**BID #1415-019**

**Fleet Facility Expansion**

**Addendum No. 2**

CARSON CITY FLEET MAINTENANCE FACILITY EXPANSION

# FIBER SPLICE DETAIL

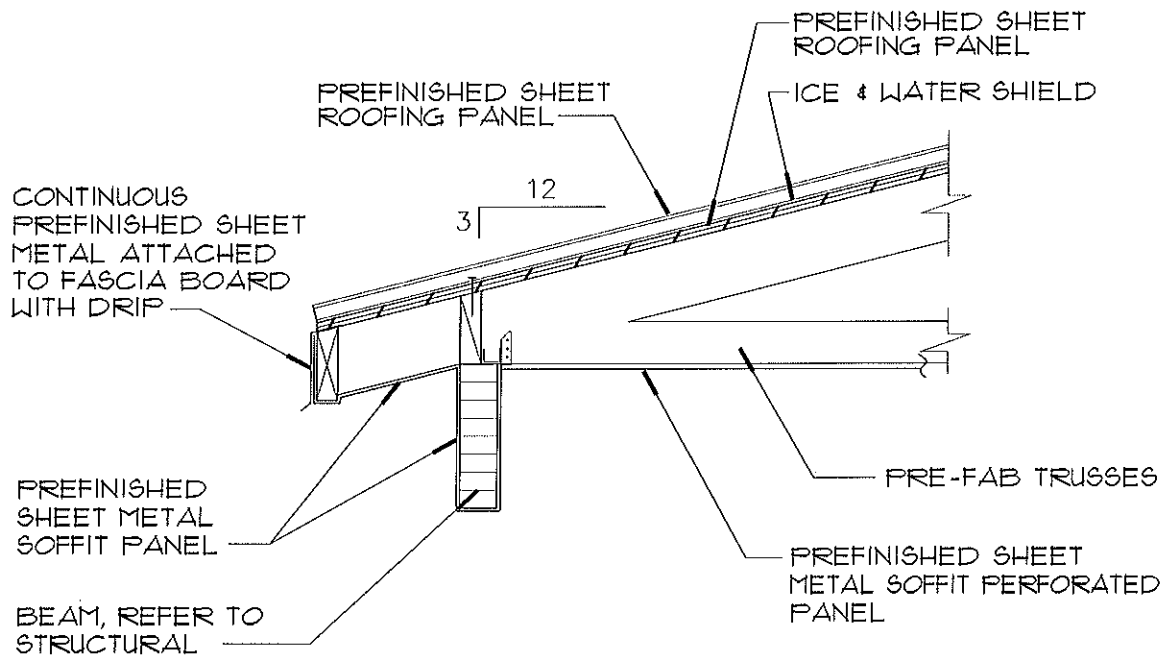
QUESTION: Can you please clarify sheet note # 4 on drawing E1.2 regarding the number of strands we're installing from the vault to the new Fleet Maintenance Telecom Room and number of strands we're splicing to the existing 24-strand fiber in the vault?

QUESTION: Follow-up on question #1 above: If we're installing a 24-strand fiber from the vault to the new Fleet Maintenance Telecom Room, are we only terminating (12) strands on the pigtail cassettes and leaving the other (12) unterminated?

RESPONSE: Detail I/E0.6 has been added to sheet E0.6 for clarification. Refer to Sketch Sk-1

RESPONSE: Detail I/E0.6 has been added to sheet E0.6 for clarification. Refer to Sketch Sk-1

## ENTRY CANOPY SECTION

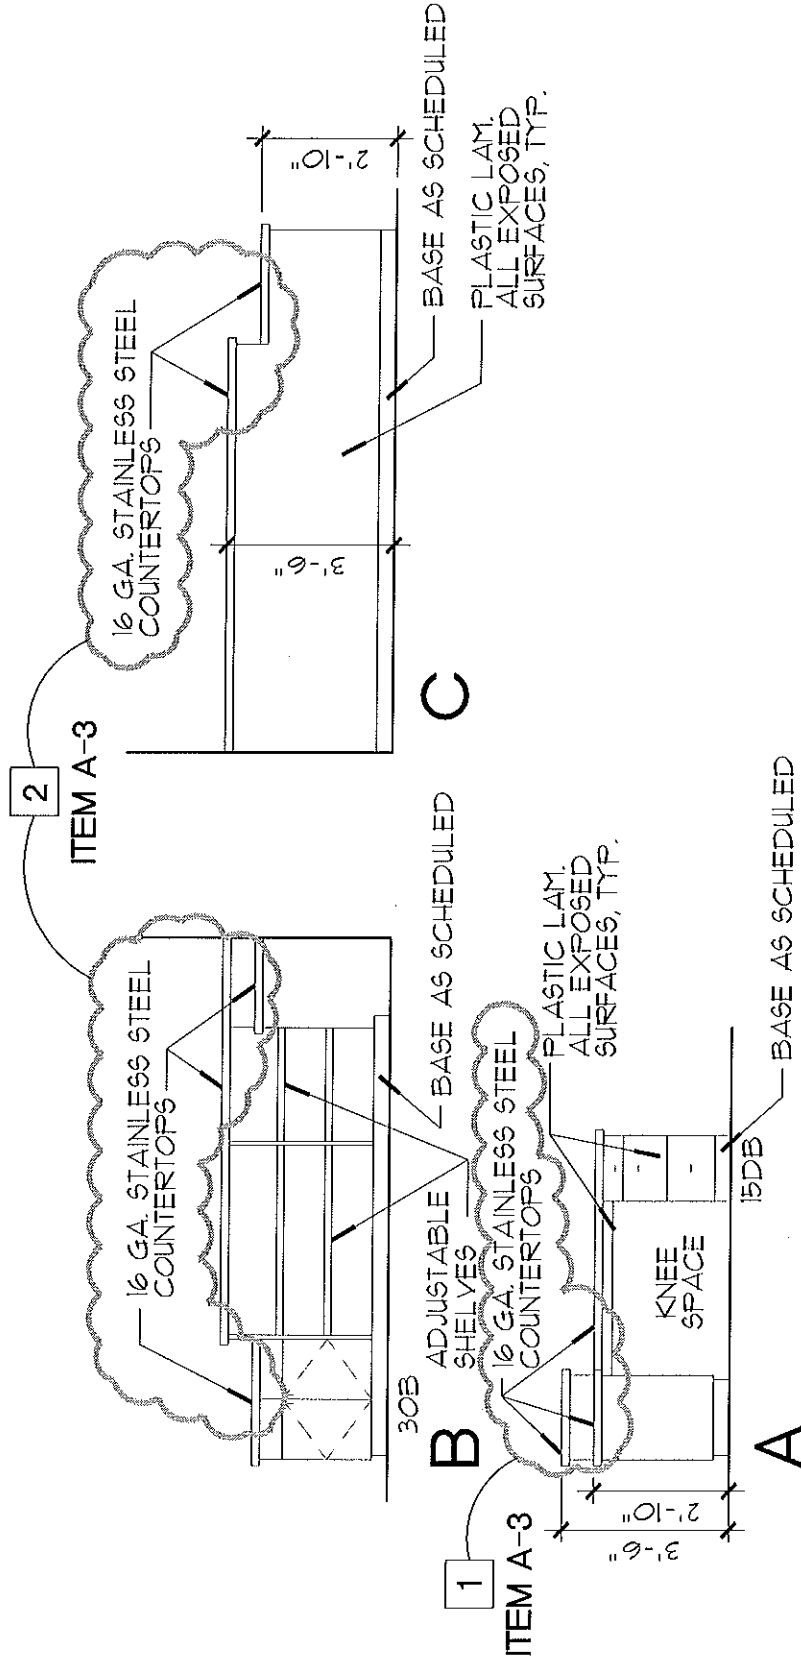
**ITEM A-2: SHEET A7, ROOF PLAN**

ADD: Detail #4 – see attached 8-1/2" x 11" Sheet 2 attached hereto as part of Addendum No. 2 dated September 4, 2014.

# Lobby - Room #100

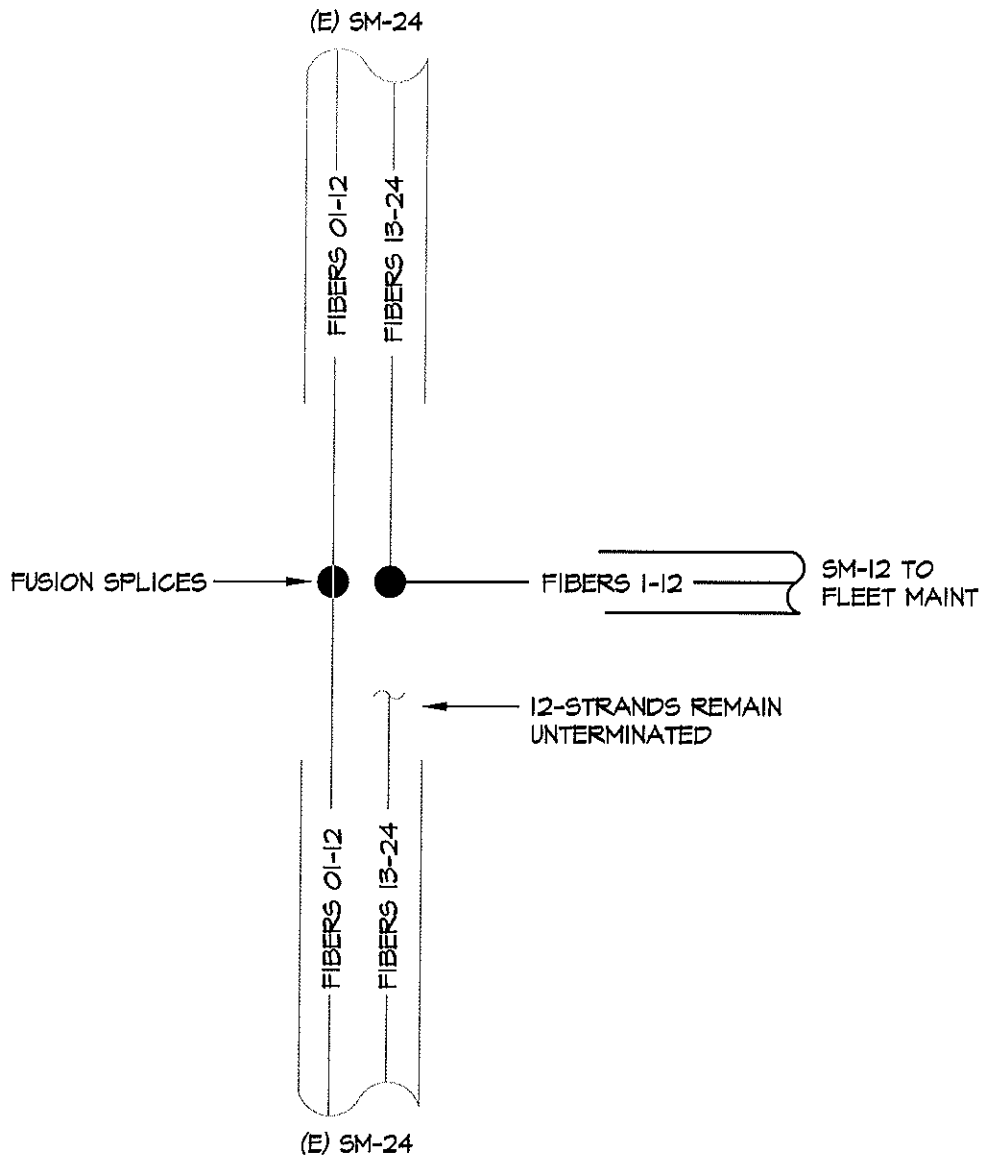
**ITEM A-3: SHEET A2.2, ENLARGED PLANS**

DELETE: Detail #6 in its entirety.

ADD: Detail #6 as shown on the 8-1/2" x 11" Sheet 3 attached hereto as part of Addendum No. 2 dated September 4, 2014.
